Access Compliance Report

Public Rights-of-Way

Intersection ID: 15457	Main Street: EAST_BV	Cross Street: LOMBARDY_CR	Location: SE
ADA ID: 93E227DDED2F	Ramp Type: PerpDiag	Initial Pass/Fail: Fail	Overall Compliance: No
		Severity Score: 25

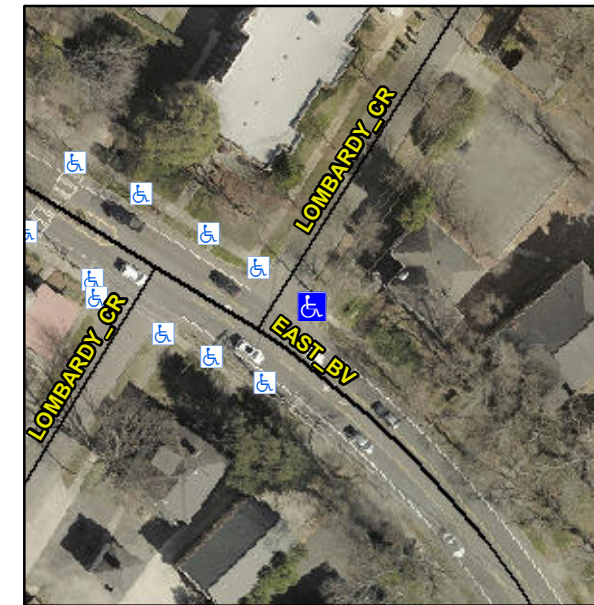
R304.2.2, R304.5.3

Compliance	Description	Data	Compliance	Description	Data
N/A	Ramp Length (in)	43.0	No	Ramp Slope (%)	8.5
Yes	Ramp Width (in)	48.0	No	Ramp XSlope (%)	5.9
N/A	Flare Type LT	N/A	N/A	Flare Type RT	N/A
N/A	Flare Slope LT (%)	N/A	N/A	Flare Slope RT (%)	N/A
N/A	Flare Traversable LT?	N/A	N/A	Flare Traversable RT?	N/A
N/A	Landing Length (in)	N/A	N/A	DWS Provided?	N/A
N/A	Landing Width (in)	N/A	N/A	DWS Contrast?	N/A
N/A	Landing Slope (%)	N/A	N/A	DWS Length (in)	N/A
N/A	Landing X Slope (%)	N/A	N/A	DWS Full Width?	N/A
N/A	Landing Curb? (Y/N)	N/A	N/A	DWS Offset (in)	N/A
N/A	Shared Landing?	N/A			
N/A	Gutter Ponding?	N/A	N/A	Gutter Slope (%)	N/A
N/A	Gutter Lip Ht (in)	N/A	N/A	Gutter X Slope (%)	N/A
N/A	Painted X Walk1?	No	N/A	Painted X Walk2?	No
	X Walk 1 Direction	To NW		X Walk 2 Direction	To SW
N/A	X Walk 1 Width (in)	N/A	N/A	X Walk 2 Width (in)	N/A
	X Walk 1 Slope (%)	5.9		X Walk 2 Slope (%)	3.8
	X Walk 1 X Slope (%)	2.2		X Walk 2 X Slope (%)	6.0

Remove & Replace Curb Ramp With Two New Directional Ramps or Equivalent.
